Access Compliance Report

Public Rights-of-Way

(Pedestrian Signals)

Intersection ID: N/A	Main Street:	Cross Street: N/A	Location: N/A
ADA ID: C743DDF60CDF	Signal Type: One Push Button-Non APS	Overall Compliance: No	Severity Score: BTN 1: N/A BTN 2: N/A No BTN: N/A
Codes/Mitigation Info/Possible Solution		Field Measurements/Component Compliance

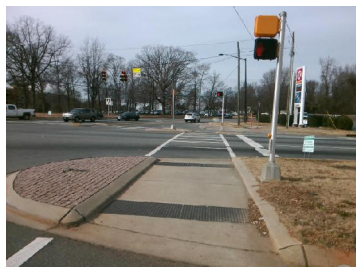
PROW/ADA: TMUTCD 4e.08, R406.2, R404.7.3, R404.7.2

Compliance	Description	Data	Compliance	Description	Data
	Button Count	Button1	N/A	Distant to Additional Button (in)	N/A
	Additional Button Present?	No		Additional Button ID	N/A
N/A	Signal Buttons Required?	N/A	N/A	Additional Ped Posts Required	N/A
	How Many Ped Street Xings?	N/A		Located In An Island/Median?	N/A
N/A	B 1 Sign Present?	Yes	N/A	B 2 Sign Present?	N/A
Yes	B 1 Sign Purpose?	Yes	N/A	B 2 Sign Purpose?	N/A
Yes	B 1 Sign Lettering & Contrast?	Yes	N/A	B 2 Sign Lettering & Contrast?	N/A
Yes	B 1 Parallel To XWalk?	Yes	N/A	B 2 Parallel To XWalk?	N/A
Yes	B 1 PAR to Button?	Yes	N/A	B 2 PAR to Button?	N/A
Yes	B 1 PAR to XWalk?	Yes	N/A	B 2 PAR to XWalk?	N/A
Yes	B 1 Clear Floor Space?	Yes	N/A	B 2 Clear Floor Space?	N/A
N/A	B 1 FWD Approach?	Yes	N/A	B 2 FWD Approach?	N/A
N/A	B 1 FWD Approach Constrained?	Yes	N/A	B 2 FWD Approach Constrained?	N/A
No	B 1 FWD Approach Reach (in)	17.0	N/A	B 2 FWD Approach Reach (in)	N/A

Yes	B 1 FWD Approach Width (in)	48.0	N/A	B 2 FWD Approach Width (in)	N/A
N/A	B 1 FWD Approach Obstruction?	Yes	N/A	B 2 FWD Approach Obstruction?	N/A
N/A	B 1 FWD Approach Obstruction Dist (in)	2.0	N/A	B 2 FWD Approach ObstructionDist (in)	N/A
N/A	B 1 PARA Approach?	Yes	N/A	B 2 PARA Approach?	N/A
N/A	B 1 PARA Approach Constrained?	Yes	N/A	B 2 PARA Approach Constrained?	N/A
No	B 1 PARA Approach Reach (in)	17.0	N/A	B 2 PARA Approach Reach (in)	N/A
No	B 1 PARA Approach Width (in)	48.0	N/A	B 2 PARA Approach Width (in)	N/A
N/A	B 1 PARA Approach Obstruction?	Yes	N/A	B 2 PARA Approach Obstruction?	N/A
N/A	B 1 PARA Approach Obstruction Dist (in)	2.0	N/A	B 2 PARA Approach ObstructionDist (in)	N/A
Yes	B 1 Clear Floor Space Slope (%)	0.4	N/A	B 2 Clear Floor Space Slope (%)	N/A
Yes	B 1 Clear Floor Space XSlope (%)	1.8	N/A	B 2 Clear Floor Space XSlope (%)	N/A
N/A	B 1 PAR Slope (%)	N/A	N/A	B 2 PAR Slope (%)	N/A
Yes	B 1 Height (in)	40.0	N/A	B 2 Height (in)	N/A

N/A	B 1 Clear Xing Direction?	Yes	N/A	B 2 Clear Xing Direction?	N/A
	B 1 Crossing Direction	To NW		B 2 Crossing Direction	N/A
Yes	B 1 DistanceTo XWalk (in)	0.0	N/A	B 2 DistanceTo XWalk (in)	N/A
No	B 1 DistanceTo Curb (in)	128.0	N/A	B 2 DistanceTo Curb (in)	N/A
Yes	B 1 Diameter (in)	2.0	N/A	B 2 Diameter (in)	N/A

Possible Solutions: Replace Signal Push Button With APS Button on New Post. Remove & Relocate Sign.
